88 Preble- revisions re

Jean Fraser, Planner

City of Portland Technical Manual

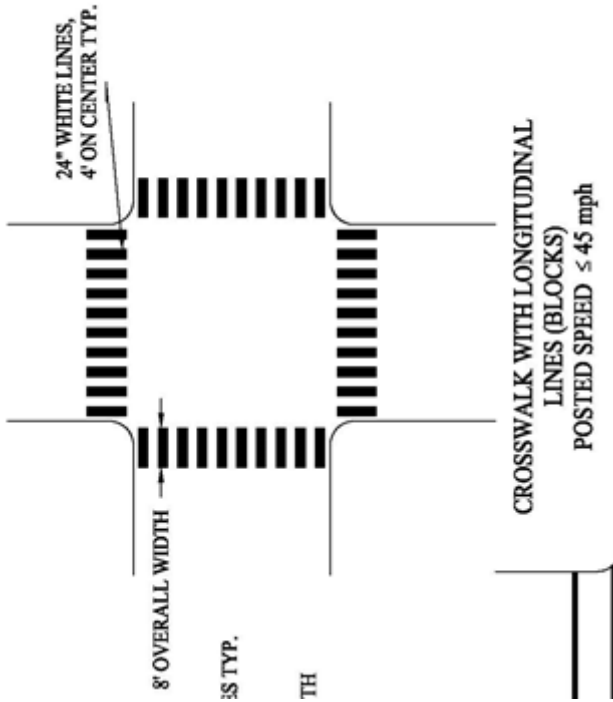
C100, C200, and C300: Show crossbars in crosswalk as per Tech Std (2 ft white, then 2 ft black) across top and bottom of Lancaster (see Tech Std extract below) and show tipdown as diagonal at corner of Lancaster/Alder to match detail in C402
